**3070-72-S**

**S E R V I C E N O T E**

**Agilent 3070 Board Test Systems**

**POSSIBLE FIXTURE FINGERTIP PINCH HAZARD**

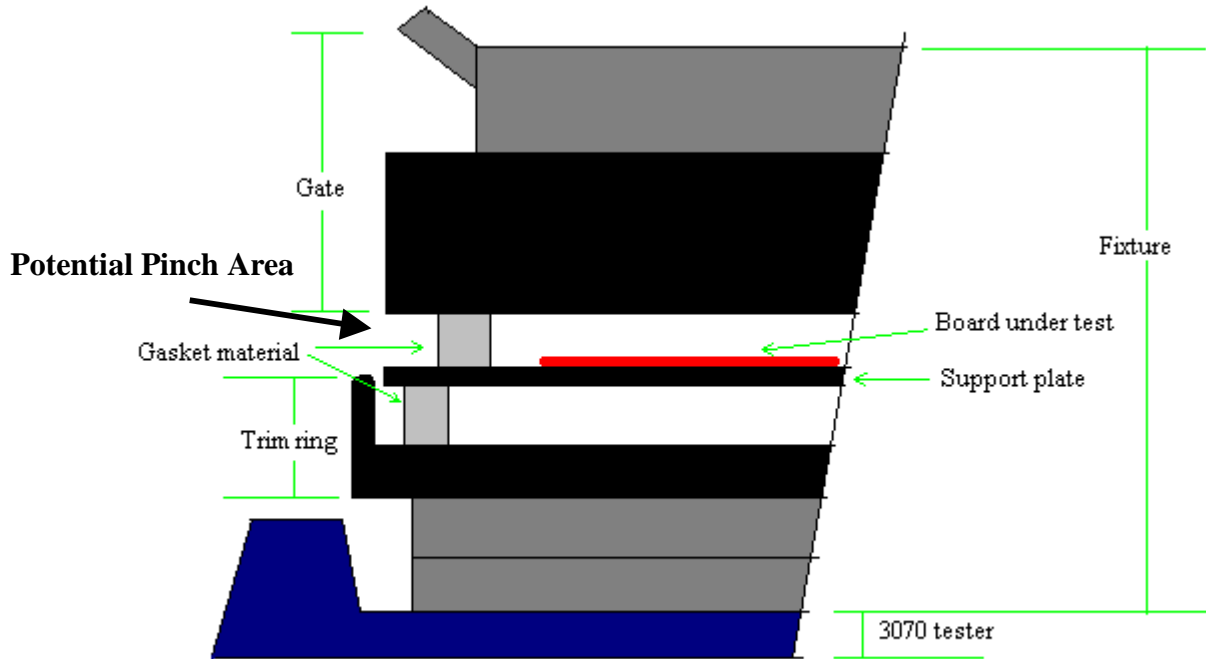
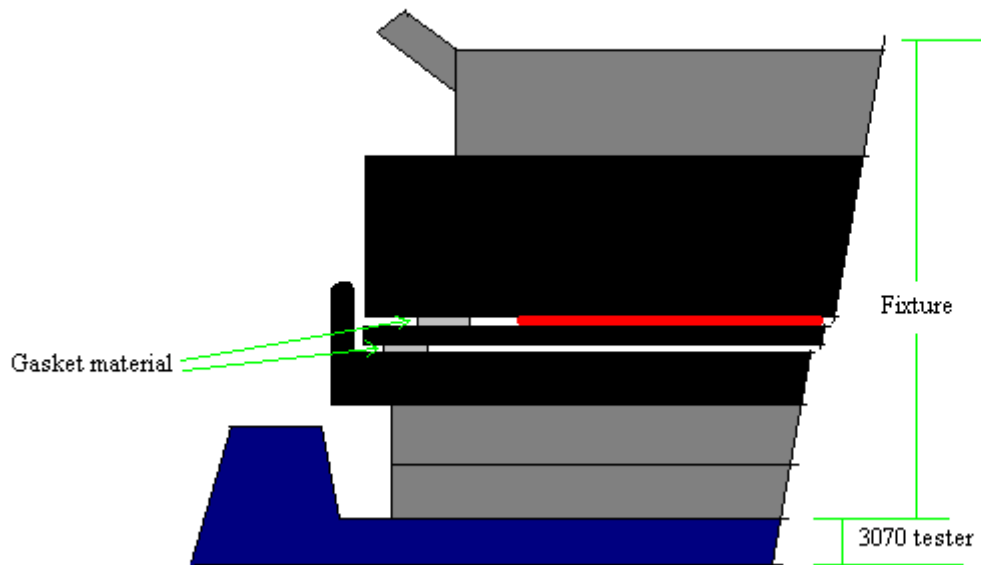
This potential hazard exists because the gate on the un-actuated fixture (vacuum off) rests above the top of the trim ring at a height greater than or equal to 4 mm. This gap is sufficient to allow an operator to insert a fingertip between the top gate and the probe plate when vacuum is off, and get severely pinched if the fingertip remains between the gate and the probe plate when the vacuum is actuated.

In the following diagrams, the front of the fixture is shown with this potential pinch area. This pinch hazard is not limited to the front of the fixture; it may be present at any location on the sides of the fixture or at the rear of the fixture.

Agilent Technologies will install a retrofit kit on all APG fixtures purchased from and supplied by Agilent Technologies that are specifically affected by the potential safety hazards outlined in this Safety Service Note. The parts and installation of this retrofit kit will be at no charge to the user for those fixtures supplied by Agilent Technologies, see the Parts Required section. Contact your local Agilent Technologies Board Test service representative for availability of the retrofit kit and for any questions concerning this Safety Service Note.

Instructions for installing the retrofit kits, along with a list of contents, will be provided in the kits. Once a retrofit kit is installed on an affected fixture, confirmation must be emailed to TSCFIXTURES ([tscfixtures@agilent.com](mailto:tscfixtures@agilent.com)). Include the APG fixture number, located on the front left side of the fixture, in the confirmation. The APG fixture number follows the format: XXXX-F.
